Product Change Notification: PCN-25-262976

CPC accessories (cable clamps, protective caps and extenders)

General Description of Changes

NEW SIZE 23 CABLE CLAMP FEATURES

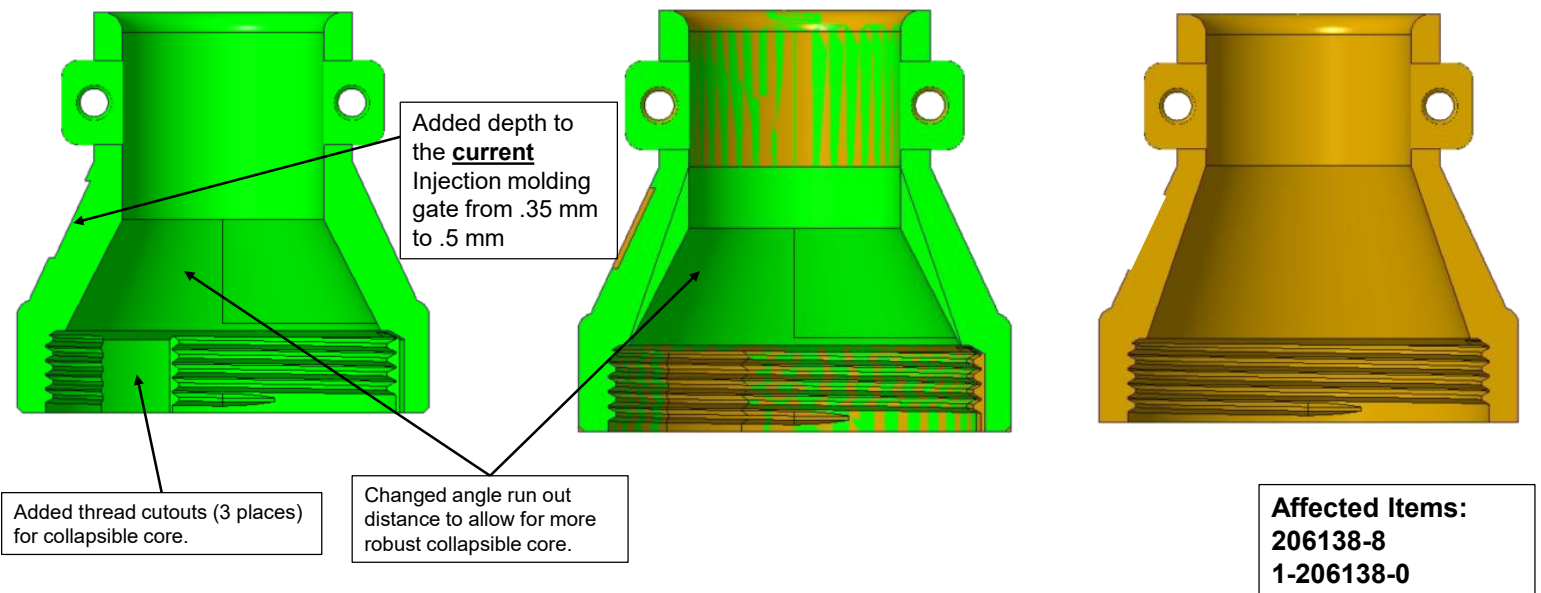
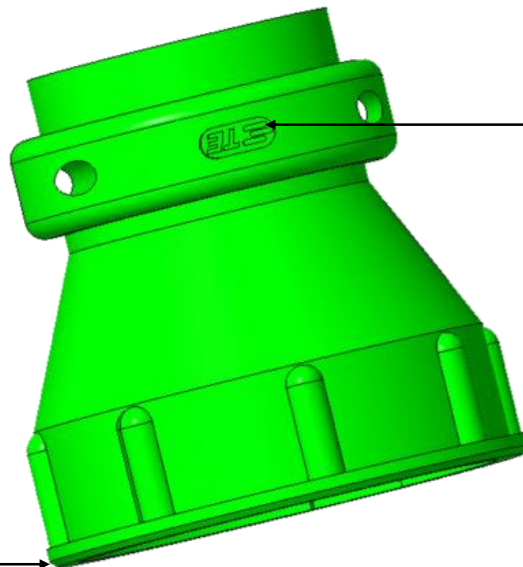
Affected Items:
206138-8
1-206138-0

NEW SIZE 23 CABLE CLAMP FEATURES

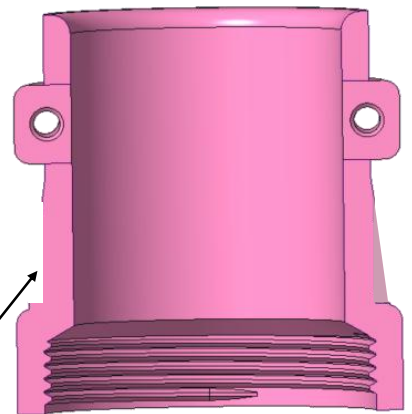
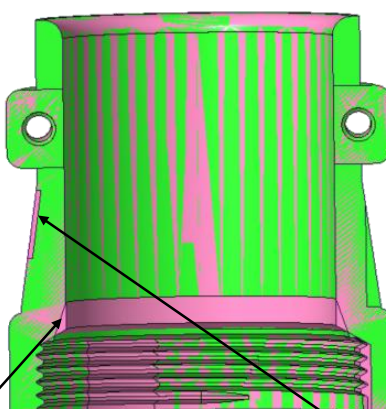
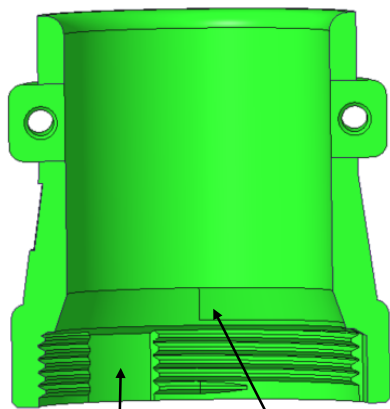
Logo change: TE

Chamfer added on this area

NEW SIZE 23 CABLE CLAMP FEATURES

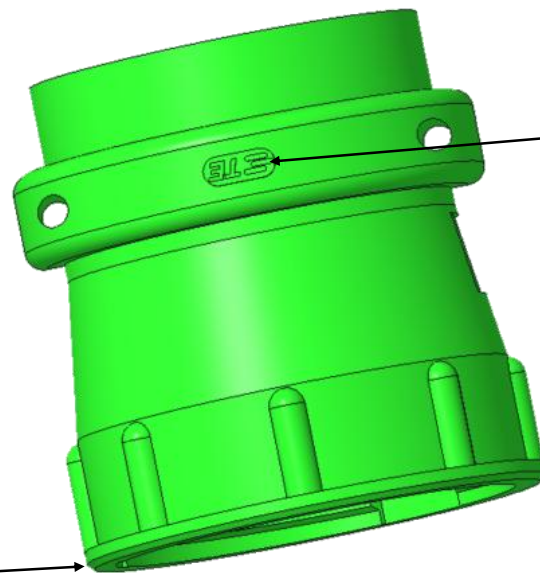
Added thread cutouts (3 places)
for collapsible core.

Changed angle run out
distance to allow us to use
the same collapsible core
for multiple part numbers

Injection Molding gate was reduced

NEW SIZE 23 CABLE CLAMP FEATURES

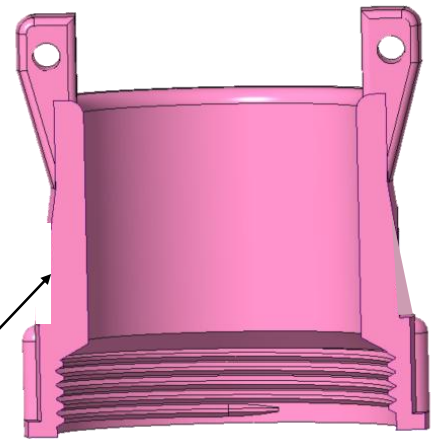
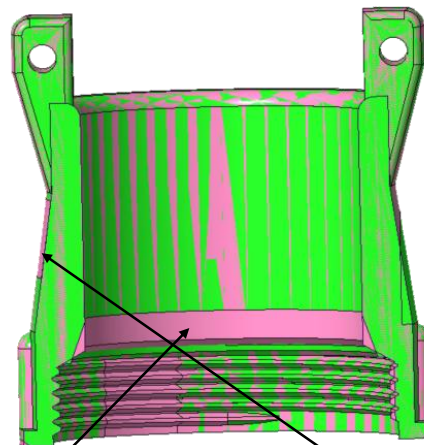
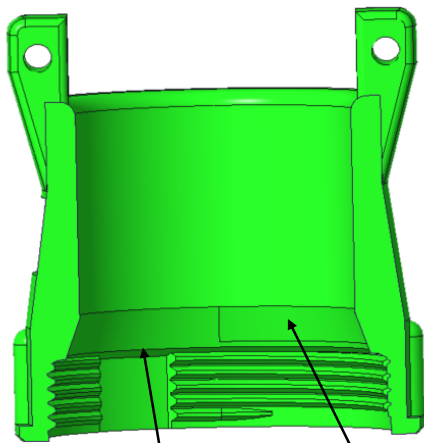
Logo change: TE

Chamfer added on this area

NEW SIZE 23 CABLE CLAMP FEATURES

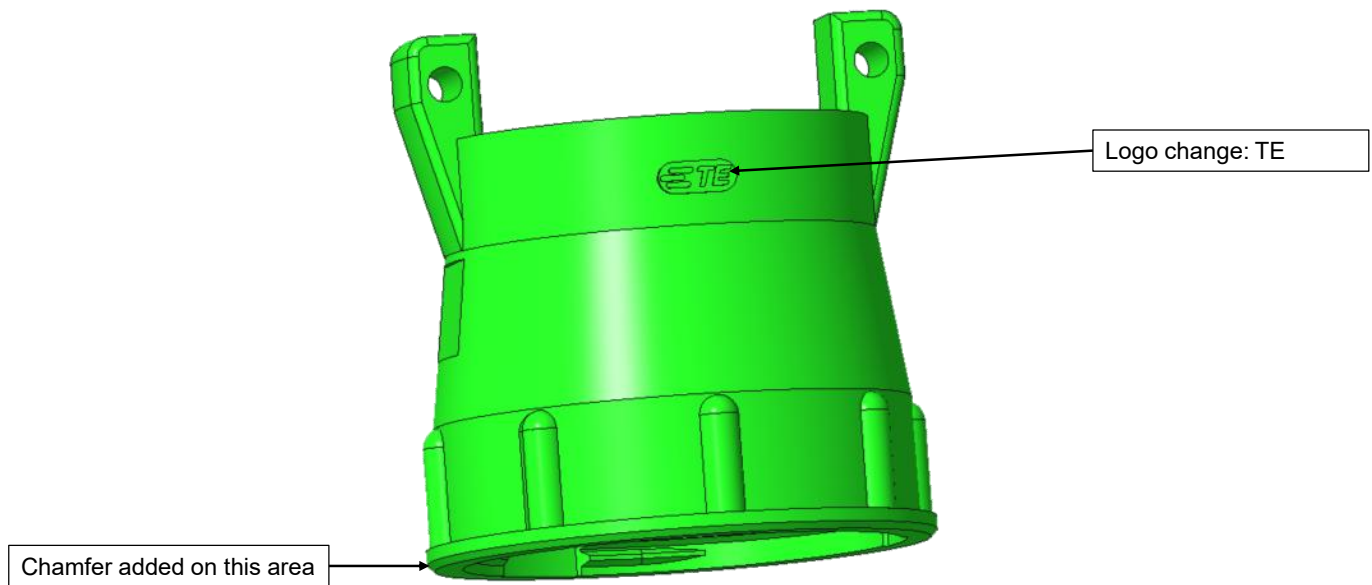
Added thread cutouts (3 places)
for collapsible core.

Changed angle run out
distance.

Injection molding gate
reduced

NEW BACKSHELL EXTENDER SIZE 23 FEATURES

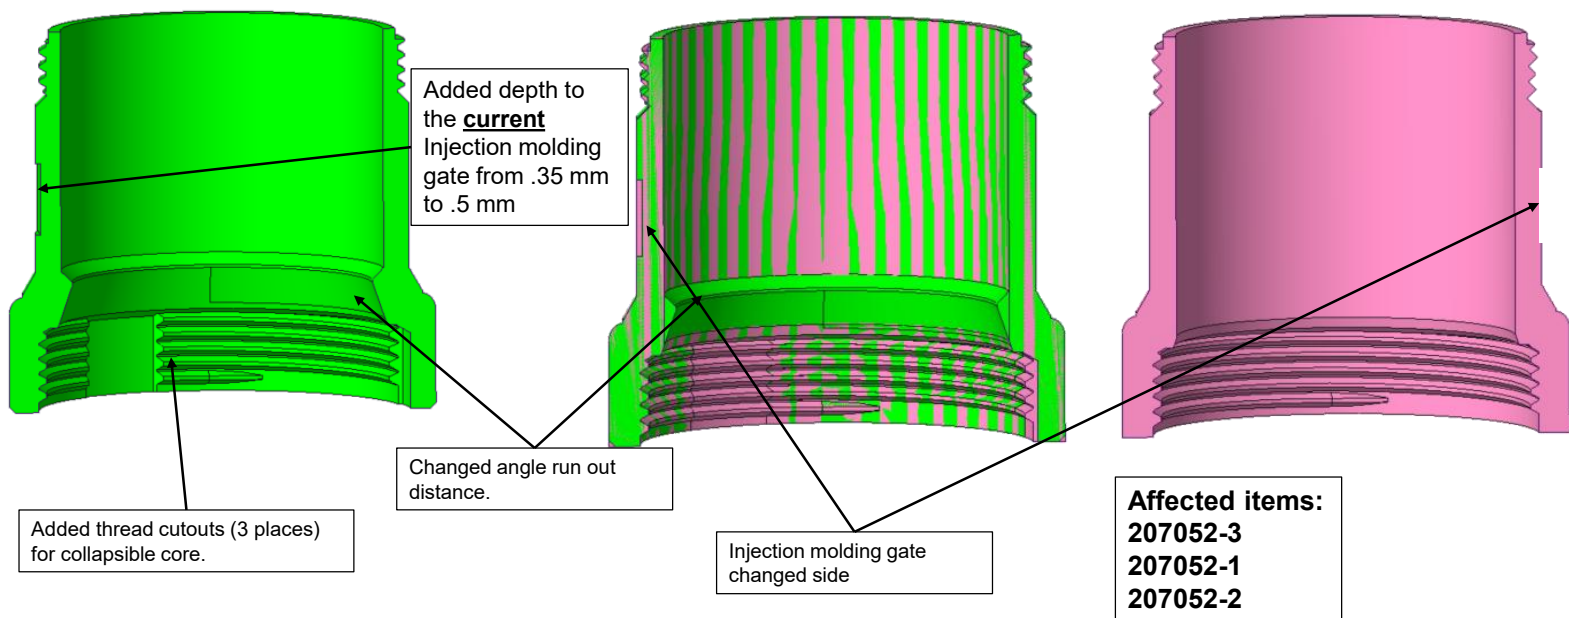
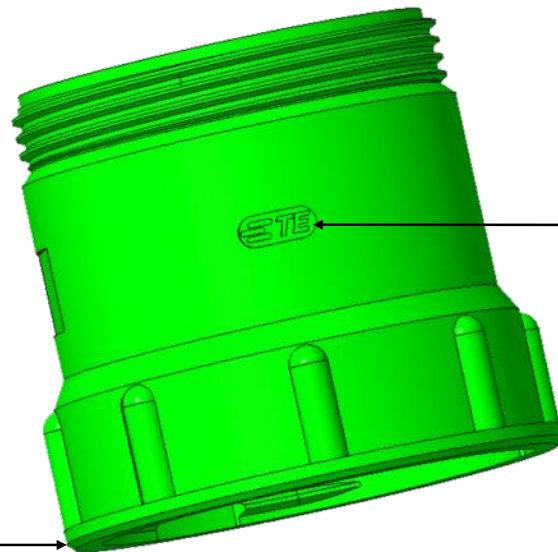
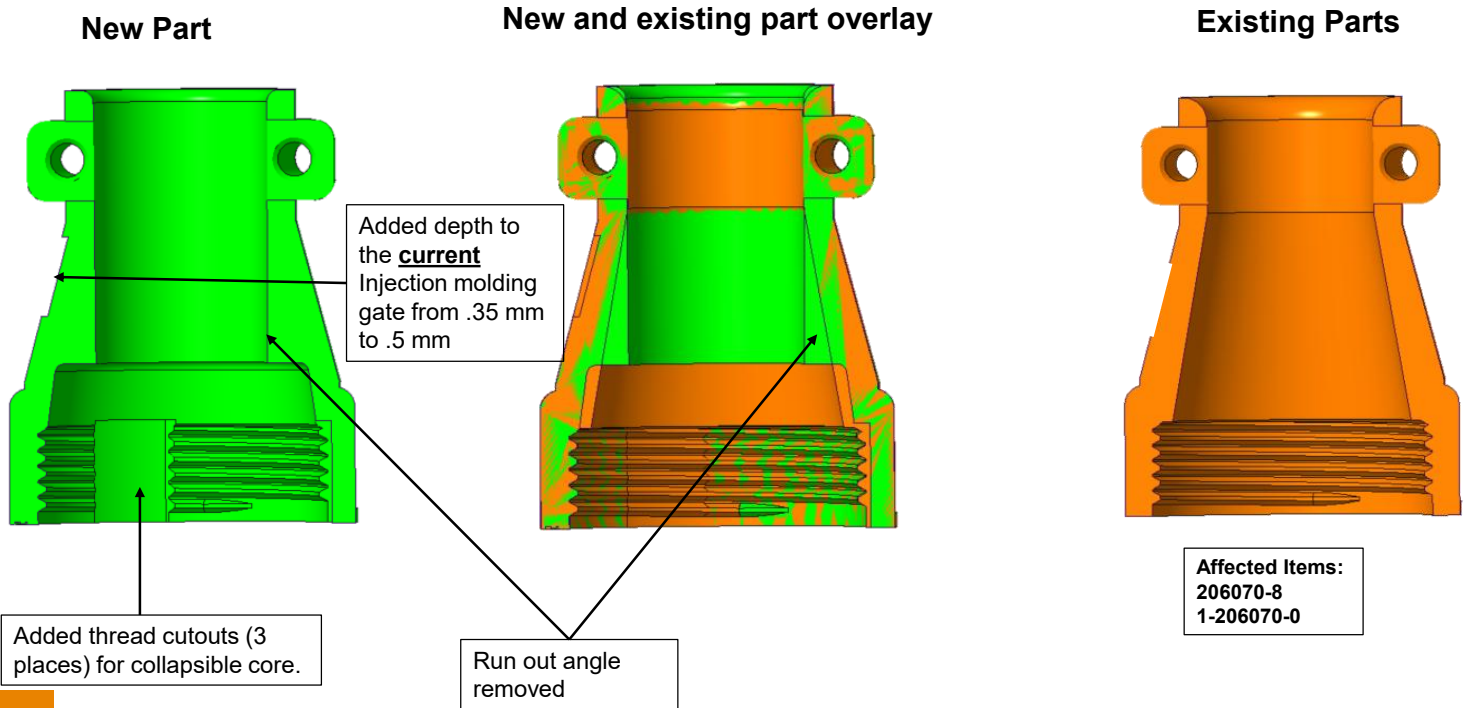
Chamfer added on this area

Logo change: TE

NEW CABLE CLAMP SIZE 17 FEATURES

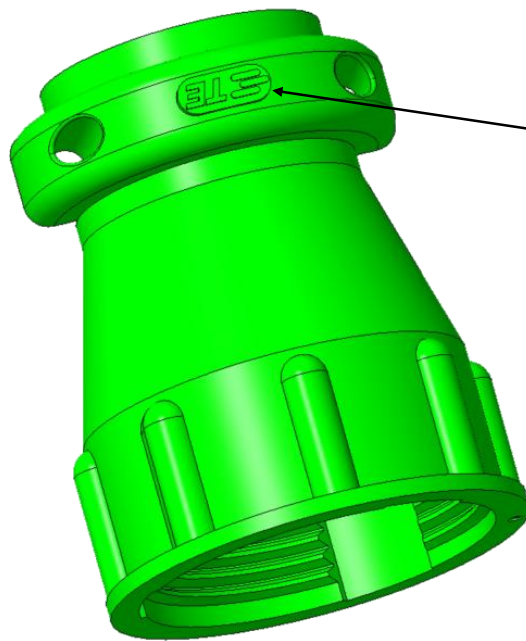
Logo change: TE

NEW SIZE 11 CABLE CLAMP FEATURES

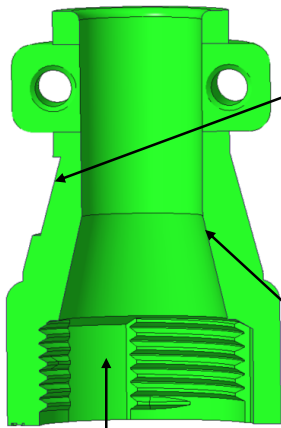
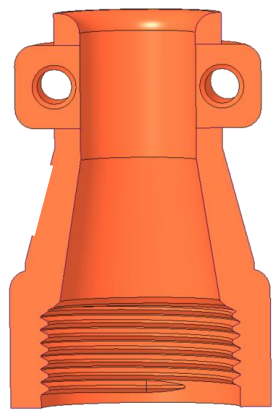
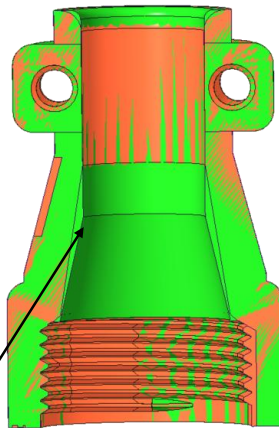
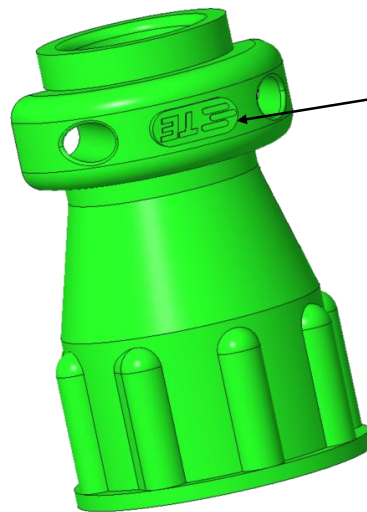
Added depth to the **current** Injection molding gate from .35 mm to .8 mm

Added thread cutouts (3 places) for collapsible core.

Changed angle run out distance from mating surface.

NEW SIZE 13 CABLE CLAMP FEATURES

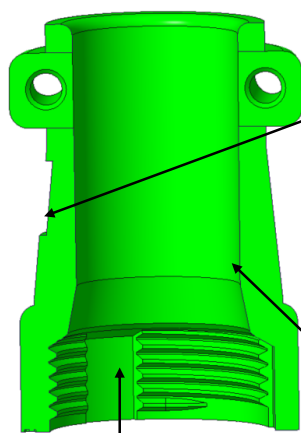
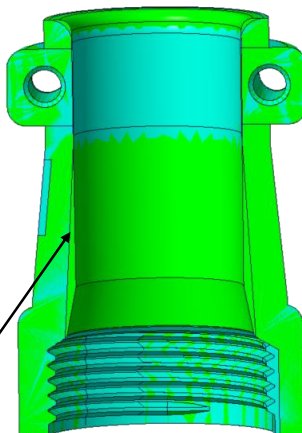
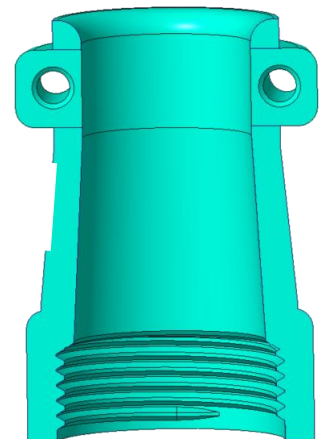
Added depth to the **current** Injection molding gate from .35 mm to .5 mm

Added thread cutouts (3 places) for collapsible core.

Changed angle run out distance.

NEW SIZE 13 CABLE CLAMP FEATURES

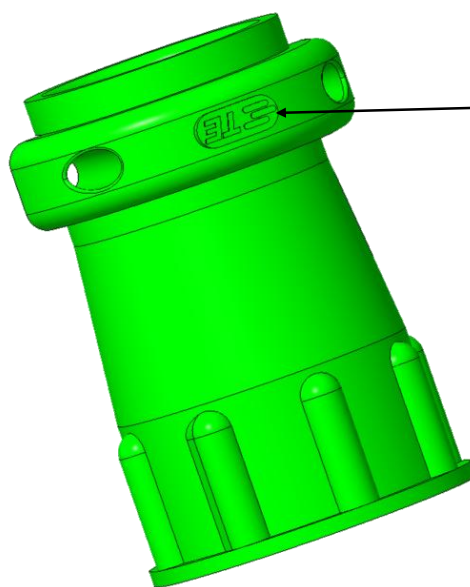
Logo change: TE
